**Economic and Social Council**Distr.: General
28 February 2018

Economic Commission for Europe**Inland Transport Committee****World Forum for Harmonization of Vehicle Regulations****Working Party on Passive Safety****Sixty-third session**

UN Global Technical Regulation No. 9 (Pedestrian safety)**Proposal for Amendment 2 (Phase 2)****Submitted by the Informal Working Group on UN Global Technical Regulation No. 9***

Figure 27
Flexible lower legform impactor: Test set-up for the dynamic lower legform impactor certification test (pendulum test, see paragraph 8.1.2.4.)

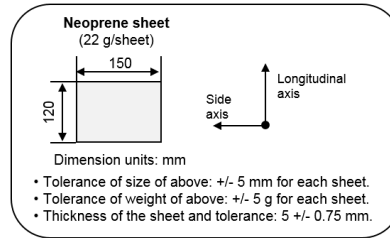
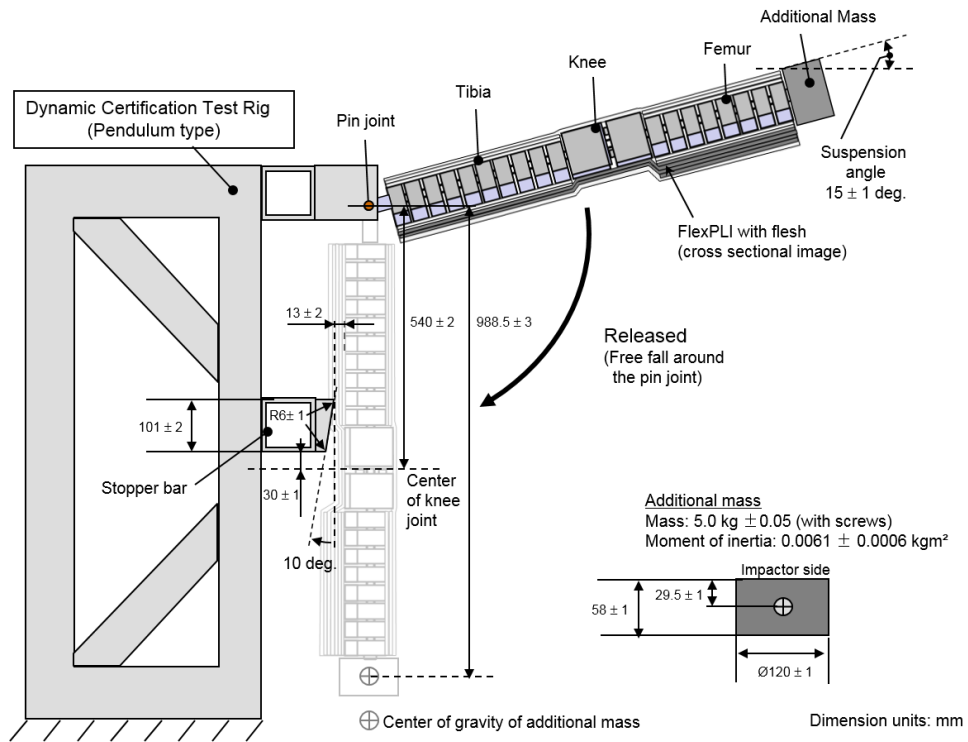
8.1.2.4.1. **The flexible lower legform impactor, including the flesh and skin, shall be suspended from the dynamic certification test rig $15 \pm 1^\circ$ upward from the horizontal as shown in Figure 27. The impactor shall be released from the suspended position and fall freely against the pin joint of the test rig as shown in Figure 27.**

8.1.2.4.2. **The knee joint centre of the impactor shall be 30 ± 1 mm below the bottom line of the stopper bar, and the tibia impact face without the flesh and skin shall be located 13 ± 2 mm from the front upper edge of the stopper bar when the impactor is hanging freely as shown in Figure 27.**

Figure 28
Flexible lower legform impactor: Test set-up for the dynamic lower legform impactor certification test (inverse test, see paragraph 8.1.3.4.)

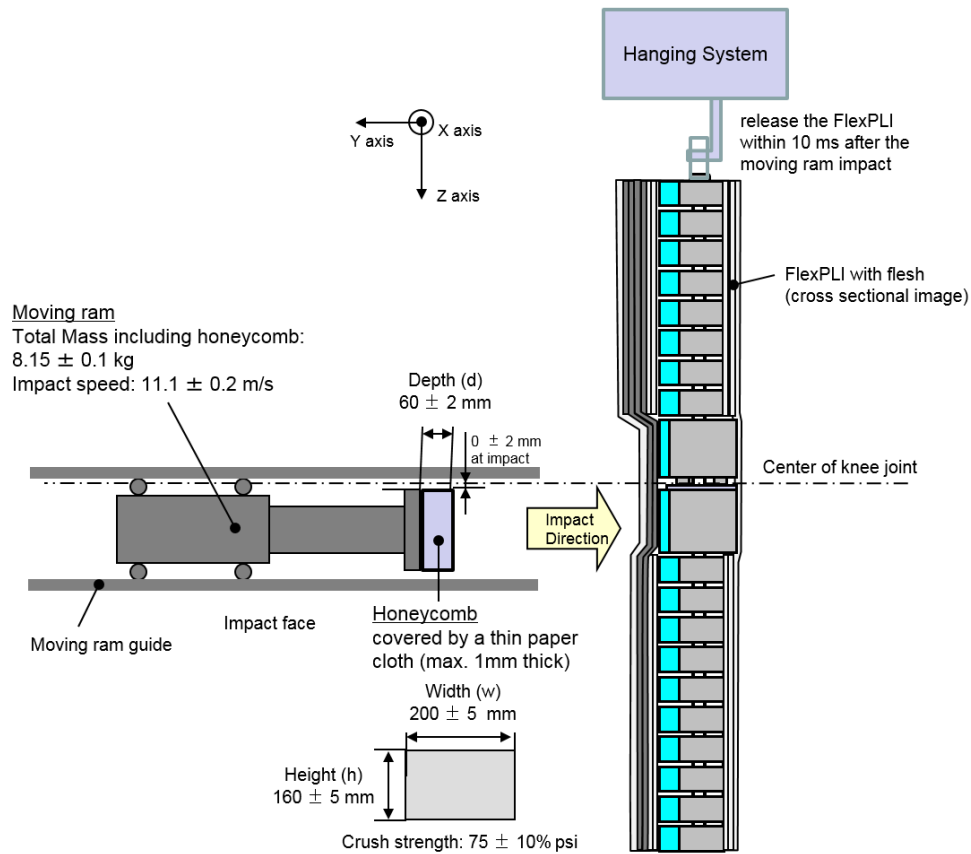
- 8.1.3.4. Test procedure
- 8.1.3.4.1. The assembled flexible lower legform impactor (with the flesh and skin) shall be hung vertically and freely suspended from a test rig as shown in Figure 28. It is then impacted by the upper edge of a linearly guided aluminium honeycomb impactor, covered by a thin paper cloth with a maximum thickness of 1 mm, at an impact speed of $11.1 \pm 0.2 \text{ m/s}$. The legform shall achieve a free flight condition within 10 ms after the time of first contact of the honeycomb impactor.

- 8.1.3.4.4. At the time of the first contact, the flexible lower legform impactor pitch angle (rotation around the Y-axis) and, therefore, the pitch angle of the velocity vector of the honeycomb impactor shall be within a tolerance of $\pm 2^\circ$ in relation to the lateral vertical plane. The flexible lower legform impactor roll angle (rotation around the X-axis) and, therefore, the roll angle of the honeycomb impactor shall be within a tolerance of $\pm 2^\circ$ in relation to the longitudinal vertical plane. The flexible lower legform impactor yaw angle (rotation around the Z-axis) and, therefore, the yaw angle of the velocity vector of the honeycomb impactor shall be within a tolerance of $\pm 2^\circ$.
